Rezoning Transportation Analysis
Petition Number: Insert Zoning Petition #2021-263
General Location Identifier: 15717222, 15717233

Revision Log:	Date	Revision Log:
	04-18-2022	First Review (WB)
	05-24-2022	Second Review (WB)

Reference (CLDSM standard detail U-05A) for street typical.

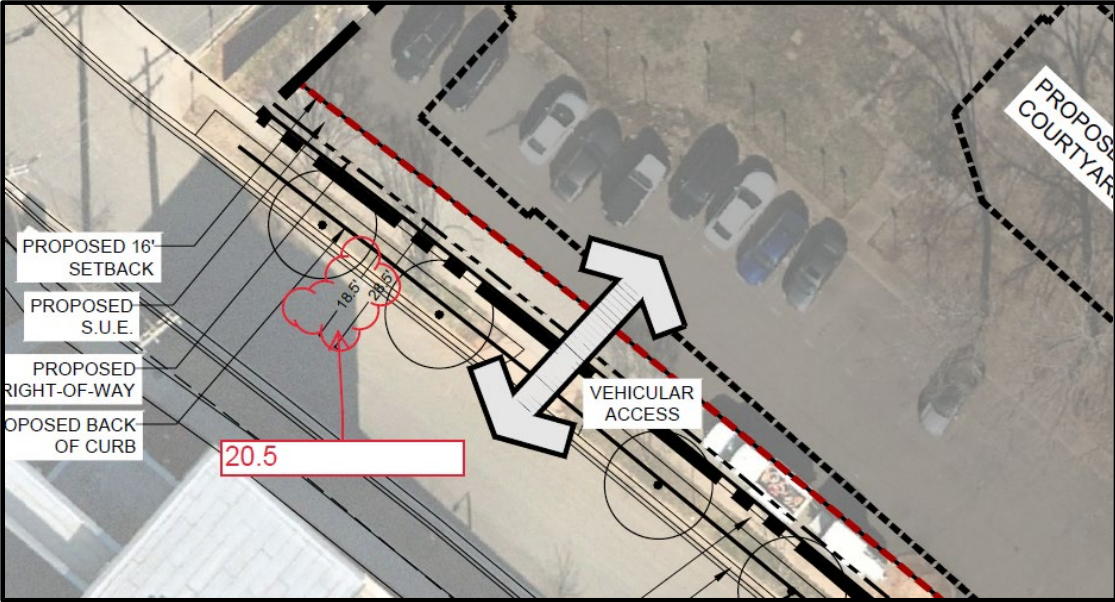
4. UNADDRESSED COMMENT WITH ADDED IMAGE FOR CLARIFICATION (5/24/2022)

Revise site plan and conditional notes to commit to construct an 8-foot planting strip, and 8-foot sidewalk on Chiswick Road per CLDSM U-05A. The site plan shall label and dimension both items from the back of curb and gutter and road centerline. The wider sidewalk also meets the Charlotte WALKS Policy.
